INDESIT company

Model type:
TLA1

Commercial code:
F034567

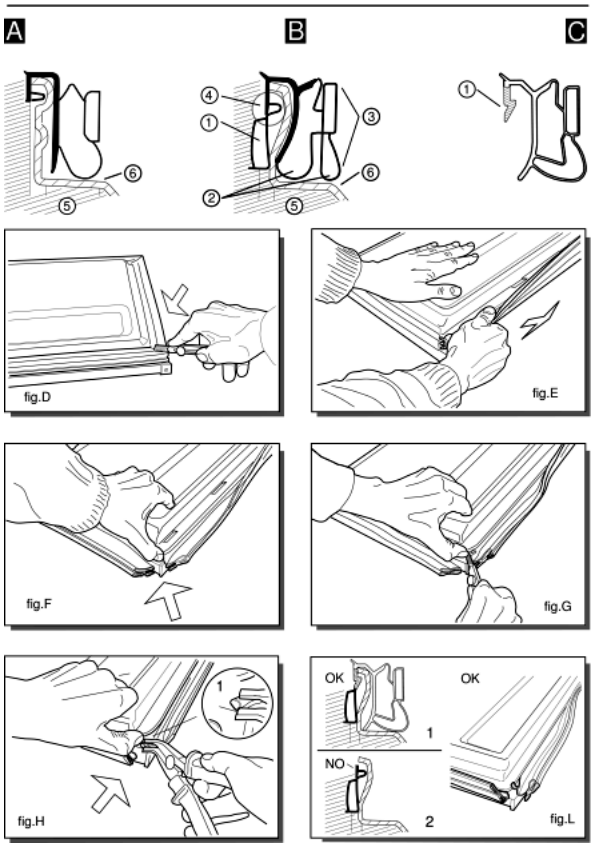
0521123: SEALS FOR DOORS FOAMED AS ONE PIECE

Various types of gaskets with different profile, as shown in figures (A) and (B), are used to fix the door (fig. A-5; B-5) and the inner door (fig. A-6; B-6) on the block foamed doors of combined freezers and refrigerators.
---Ilpea profile 245; 179; 412 (fig.A)
---Ilpea profile 287 (fig.B)
When replacing gaskets with profiles 245; 179; 412 these are fixed with screws (2 per corner) to the door.
Gaskets with profile 287 can not be used as spare parts but are designed to house the Ilpea type 900 gaskets (see figure C).
When replacing the gasket (287), once it is removed you will find a pocket (fig. B-1) between the door and inner door.
The rigid tooth (fig.C-1) of the gasket (900) is inserted inside between the pocket and the inner door, doing away with the need for screws.
Gasket with profile 287 is easy to identify since it has an exterior double edge (fig.B-2) which acts as a cushion when the door is closed.

To replace this gasket, follow these steps:
---Dismount the door and cut the four corners of the gasket along the joint (fig.D);
---lift the gasket and pull it carefully along its full length without tearing it (fig.E).
The purpose here is to detach the inner door slightly from the foam along the exterior edge for a depth equal to that of the gasket (fig.B-3);
---lift the corner of the inner door slightly, prising it up with your thumb (fig.F). Do not use a tool which might break the inner door;
---continue cutting the gasket inside the inner door for about 6 mm (fig.G);
---push in the tip of the pliers (type USAG N131) and pull outwards until you see the top edge of the pocket (fig. B-4) which is empty (fig.H-1);
---if you carry out this operation correctly (fig.L) you will be able to pull off the top edge of the pocket for the full length of the door.
If the gasket tears before the top edge (fig. L-2) you should repeat this operation from the other corner of the door.

---once the gasket (287), has been removed the space above the pocket (fig. L-1) can house the rigid tooth (fig. C-1) of the gasket 900.
When you fit this gasket ensure that it lies flush against the edge for the full length of the door.
If the rigid tooth is difficult to fit, eliminate any residues of foam between the door and the inner door in the gasket area.
fig.5131549A
